INDESIT company

Model type:
AD1000EX

Commercial code:
F027764

Notices

FIG. 1

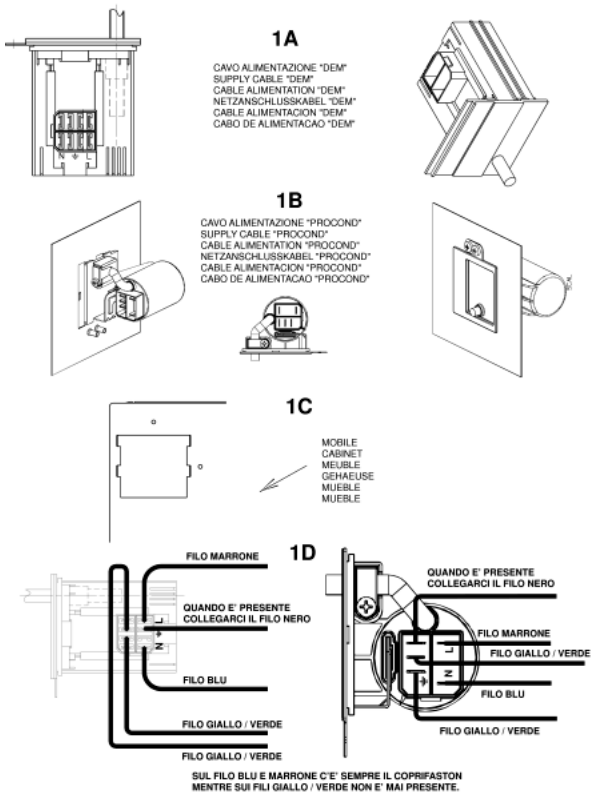
n1040276: Power supply cable + integrally moulded filter.

All appliances produced in the Comunanza (from serial no. 21008.0001), Teverola (from serial no. 21111.0001) and Brembate (from serial no. 21119.0001) factories have been equipped with power supply cables with integrally moulded filter (see fig.1 - 1A and 1B) and new units having a specific opening at the back for fixing the new cables (see fig. 1 - 1C).
The new units, together with the new cables, can be used in place of the premodification ones, by connecting the wiring to the cable, as shown in figure 1 - 1D.
The codes of the new units and of those replaced (ESI - table n1040276fig02), which will be managed until stocks run out, are given below.

The new power supply cables are:
Code 091632 - Power supply cable 3x1 schuko 1.5m+capacitance filter;
Code 091633 - Power supply cable 3x1 schuko 1.5m+inductive filter;
Code 091634 - Power supply cable UK 3x1 l= 1950mm + inductive filter;
Code 091635 - Power supply cable UK 3x1 l=1950mm+capacitance filter;
Code 091636 - Power supply cable l=2.55m AUS+inductive filter;
Code 091641 - Power supply cable l=2550mm AG +capacitance filter;
Code 091642 - Power supply cable 1.85mt SHUKO no inductive filter;
Code 091643 - Power supply cable 3x1 (CH) 1.5m+inductive filter;
Code 091645 - Power supply cable 3450mm SOUTH AF.+capacitance filter;
Code 091690 - Power supply cable shuko l2.55m KOREA+inductive filter;
Code 091689 - Power Supply cable l=2550mm AG+inductive filter.

IMPORTANT: the fixing / continuity screw is a specific self-scraping screw (code 092348) that ensures earth continuity between the filter and the unit. The same screw must be refitted in order to guarantee machine conformity.

The premodification wirings, are also managed for modified products by making the connection to the terminal block of the new cable as shown in fig. 1 - 1D.
The wiring diagrams given in the Documentation remain unchanged.

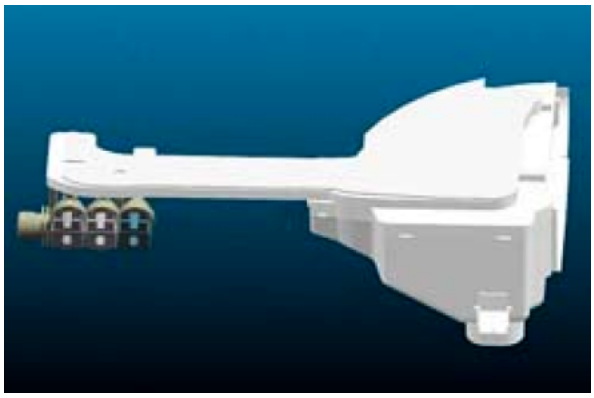
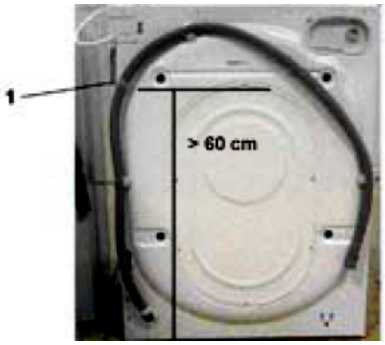
n1040282: New drainage OKO system.

From serial number 21219.0001, the new "OKO" drainage system has been introduced on the washing machines produced in the Comunanza factory.

The new items are:

- EEPROM (the OKO system requires a new setting of load timing parameters). THE NEW EEPROMS REPLACE ALL THE ONES CODED PREVIOUSLY.
- BOWL (hopper tube hole shifted forwards);
- DETERGENT LOADING TUBE (see fig. 1);
- PRESSURE SWITCH (changed levels);
- OKO PUMP BOWL BLOWER + BALL (see fig. 2A, 2B and 2C);
- CONDUCTIVITY SENSOR (if provided, it is shorter than the premodification item);
- DRAIN PUMP (without detergent collecting tube connection);
- HOPPER (shifted in front of detergent loading tube connection). Fig. 3A post-modification. Fig. 3B premodification);
- AIR TRAP (different shape);
- PRESSURE SWITCH TUBE (different length);
- DRAIN TUBE STOP (specific);

In particular, the OKO system consists of a spherical plastic component inserted in the tube that connects the bowl to the drain pump (see fig.2 A).
At the beginning of each wash cycle the washing machine fills water for 10 seconds and activates the drain pump for 2 seconds. In this way, the water level in the bowl is different from that in the drain tube; this difference increases the thrust of the ball upwards, closing the bowl-pump connection tube hermetically (see fig. 2D).
This system has the double advantage of:

1) separating the wash water and the water in the drain hose, thus saving energy during the heating phase;
2) and ensuring optimal use of all the detergent.
With the introduction of this new component, the detergent collecting tube is no longer required and the pump has one hole only to convey water from the tank.
For the correct operation of the OKO system, it is important that the drain hose of the washing machine remains fixed to the back of the unit with a plastic clamp (to this end, the clamp withstands a 25 kg load; see reference 1 in fig. 4); otherwise, the drain hose must absolutely reach the height of the clamp. (minimum 60 cm.)

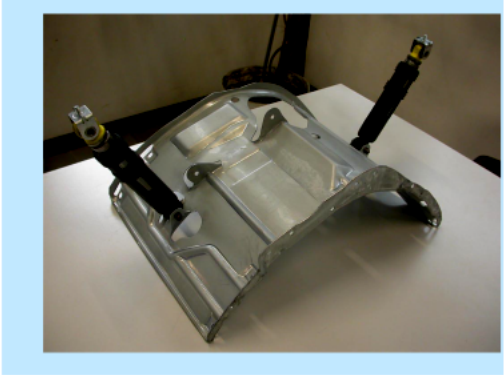
n1040325: New shock absorber fixing system with pin

From serial no. 40427.0001, shock absorbers have been fixed to the tank unit cradle with two 11 mm pins code C00110163 (see fig. 01 and 02 enclosed) in place of the 8 mm screws code 093750 and relevant locking nuts code 030443, on all washing machines and dryers produced in the Comunanza factory.
The items affected by this modification are:

1) The cradles have the same Service code, as they can be used in place of the new ones after widening the shock absorber fixing holes to a diameter of 10 mm.
Code 093848 - Tank unit cradle 46 lt
Code 093878 - Tank unit cradle 40 lt.

2) The new shock absorbers, with fixing bushing having no s/steel spacer, are not managed as they are interchangeable with the premodified items (make sure they are CIMA type, as the managed items), fixed with M8 screws code 093750 and related locking nut code 030443 (see figs. 05 and 06).
Code 093884 - Shock absorber 80 N
Code 093885 - Shock absorber 100 N

To remove the shock absorber from the tank, first extract the pin with a few hammer taps (see fig.03) until it is aligned with the tank bracket and then pull it out with a pair of pliers (see fig. 04).
(To refit the shock absorber use a new pin. Insert the pin until the toroidal edge is aligned with the bracket.)

Fig . 001

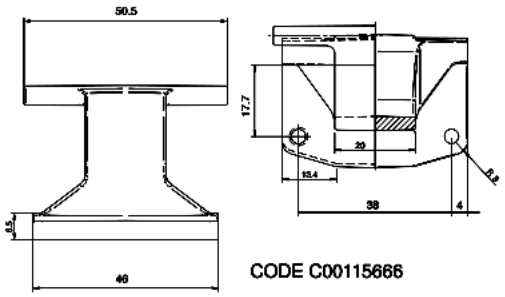
n1040349: Introduction of 150° Zamac hinge on Ariston 46 models.

From serial no. 50207.0001, all Ariston models produced in the Teverola factory (see table 001 attached) with industrial code (given on the rating plate) starting with 46, have been equipped with a Zamac hinge with 150° opening angle, code C00115666

(see Fig.001).
This modification has involved the introduction of the following items:

Code C00115670 - Complete door EVOII 150° white 27 with standard glass;
Code C00115674 - Complete door EVOII 150° white 27 with long glass;
Code C00115667 - EVOII body for 150° hinge white 27;

The premodified items are not interchangeable separately with the modified ones.

Code C00110133 - Complete door EVOII Standard 180° white 27 standard glass;
Code C00092157 - Complete door EVOII 180° white 27 long glass;
Code C00096193 - EVOII body for 150° hinge white 27;
